SUBJECT: MILLSTONE POWER STATION UNITS 2 AND 3 – NRC SPECIAL INSPECTION  
REPORT 05000336/2014011 AND 05000423/2014011

Report Nos.: 05000336/2014011 and 05000423/2014011

Facility: Millstone Power Station, Units 2 and 3

#### 2.1 Failure to Complete a 10 CFR 50.59 Evaluation for Removal of Severe Line Outage Detection

**FIGURE 3 – TRANSMISSION LINE TOWERS - NEW DESIGN**

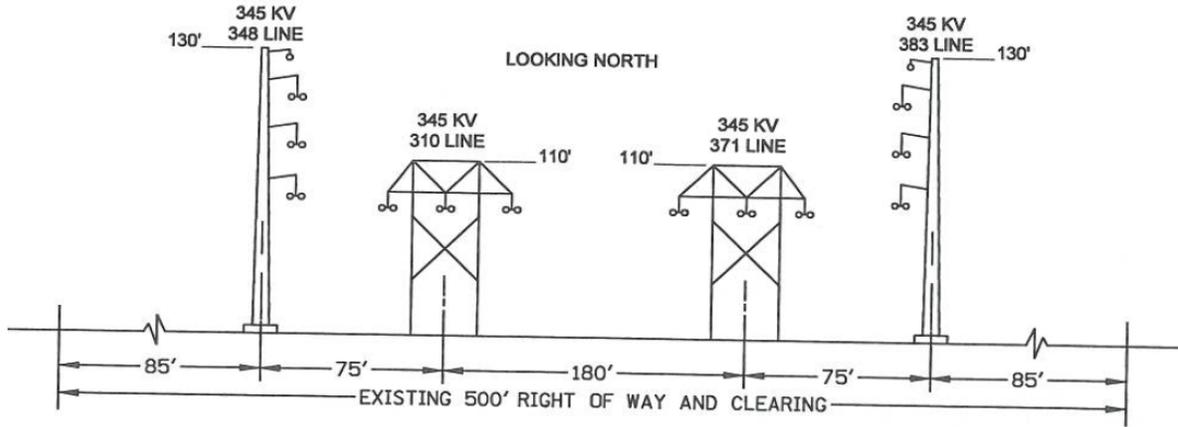
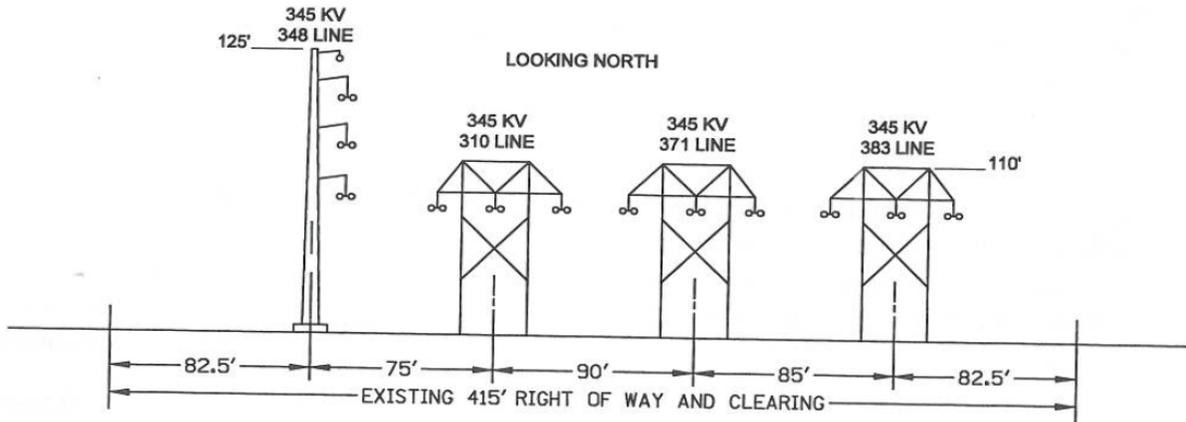
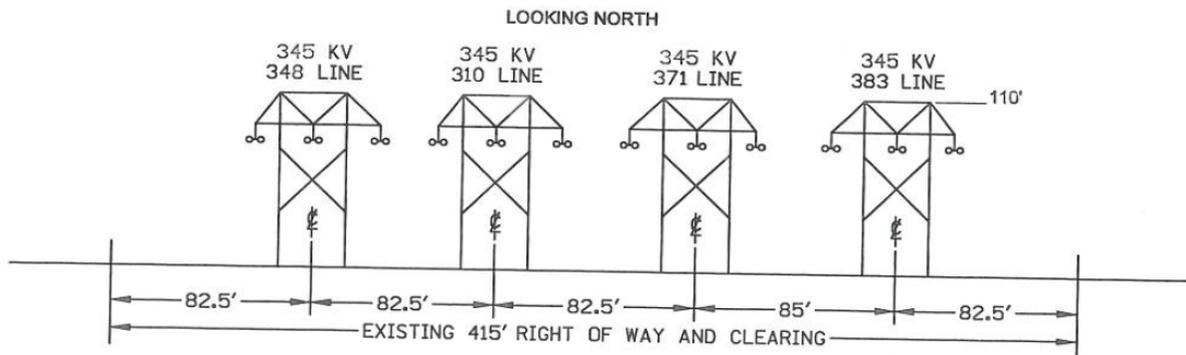
The team identified that in 2012 and 2013, Northeast Utilities, the transmission entity and the owner of the Millstone switchyard, modified transmission circuits at the Millstone switchyard to eliminate the existence of the simultaneous double circuit fault scenarios, which as discussed previously, existed due to the physical placement of two transmission lines on a common tower. This modification by Northeast Utilities installed two new transmission paths going out of the Millstone switchyard. The new offsite transmission line configuration consisted of four, single 345 kV transmission lines each located on a single circuit tower and transmission path, which is illustrated in Figure 3 of Attachment 4, of this inspection report.

The team also determined that the design change did not address the possibility of a mechanical failure of transmission line towers, such as an existing tower falling on the new tower and causing simultaneous failure of two transmission lines. The intent of the design change was to eliminate the simultaneous double-circuit tower fault scenario by separating each of the 345 kV transmission lines on its own tower and its own transmission path. The new design installed two new transmission paths that are located approximately 75 feet (average) from the existing paths within a common right-of-way. The team determined that the 75 feet separation between the existing towers and new towers may not be adequate to prevent a simultaneous double circuit fault scenario if one of the original transmission towers (130 feet tall) falls over onto the newly-installed tower (110 feet). Therefore, the new configuration of the transmission lines is also vulnerable to the same credible fault scenario resulting in loss of three out of four transmission lines. Unit 2 UFSAR Section 8.1.2.1 addressed the original tower heights and the ground clearances between towers. The UFSAR details that the 330 feet separation indicates significant enough clearance to provide adequate physical independence of the transmission lines. The team found that the design change documents did not address this failure mode in the Failure Mode and Effects Analysis section, as required by procedures.
